## TECHNICAL MEMORANDUM

**DATE:** April 14, 2015  
**TO:** Gina Auld  
**FROM:** Yammie Ho  
**SUBJECT:** Supplemental Response to City's Comment on 206th Ave SE Stop Control  
**CC:**  
**PROJECT NUMBER:** 554-1521-075  
**PROJECT NAME:** East Lake Sammamish Trail - South Sammamish Segment A

This memorandum supplements the November 2014 and January 2015 memorandums written in response to comments regarding the right of way assignment for the Driveway #4 (206<sup>th</sup> Avenue SE) intersection.

SHEET NO.  
19 OF 79  
**SP3**

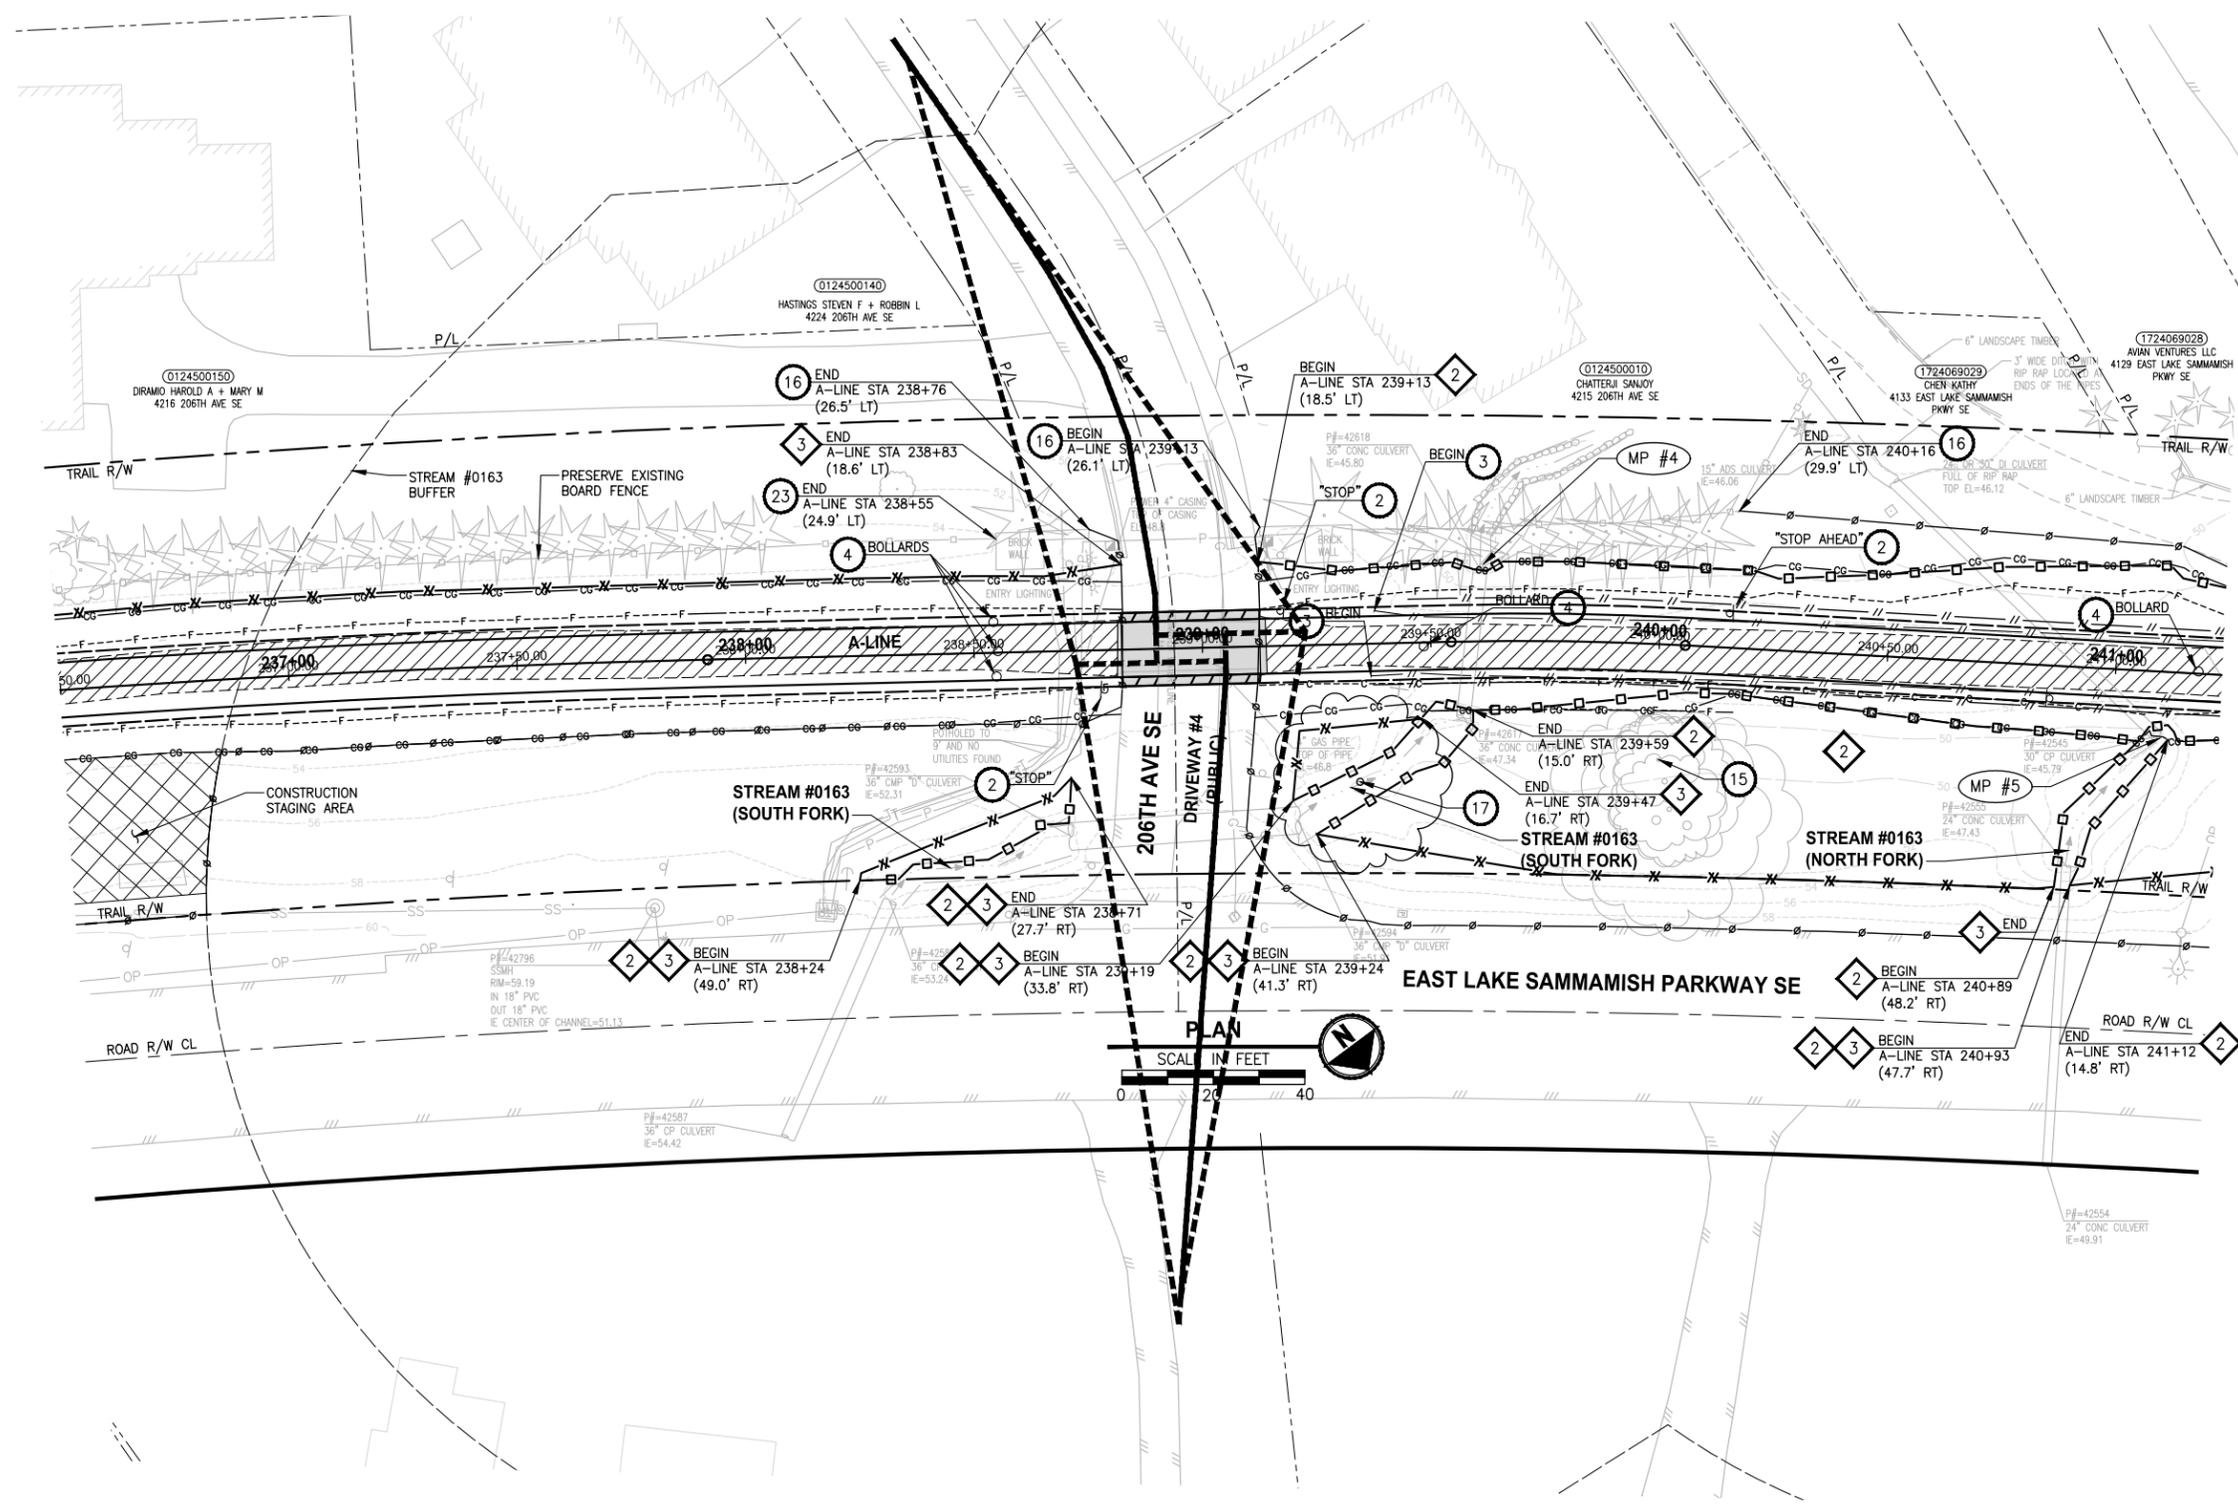
Sight triangles are shown on the attached figure, as a reference. There is currently only 6-feet between the existing curb and the edge of an existing brick wall that forms the entrance to the neighborhood. This only provides 55-feet of intersection sight distance towards the west for trail users heading northbound, which falls well short of the 145-feet to meet guidelines for a 15 mph design speed on 206<sup>th</sup> Avenue SE. To maintain the stop condition on the reconstructed trail and also meet design guidelines, the existing decorative brick wall, built-in light, and vegetation on the southeast corner of the intersection would need to be removed or relocated outside the minimum sight distance triangle. The current priority assignment (stop signs on 206<sup>th</sup> Ave SE) as shown on 95% plans, does not require removal of the brick wall and landscaping southeast of the intersection.

If the right of way assignment were to be changed and these sight obstructions were to remain, a design justification with an engineer's stamp would be needed. The justification would need to consider the following:

1. The rationale of assigning the right of way to the approaches with less volumes, which is not recommended in the AASHTO guideline.
2. Accident history between vehicles and non-motorized users at this intersection and whether limited intersection sight distance between northbound trail users and eastbound vehicles was a factor.

3. Analyze whether additional mitigation is needed for the limited intersection sight distance. This could include speed bumps on 206<sup>th</sup> to force vehicles to slow down before the intersection, flashing signal, and a mirror on the north side of the intersection so vehicle and trail users can see each other prior to the intersection.

Based on the guidance in the AASHTO and safety consideration, Parametrix does not find adequate justification for switching the right of way assignment even if the sight obstructions were to be removed.
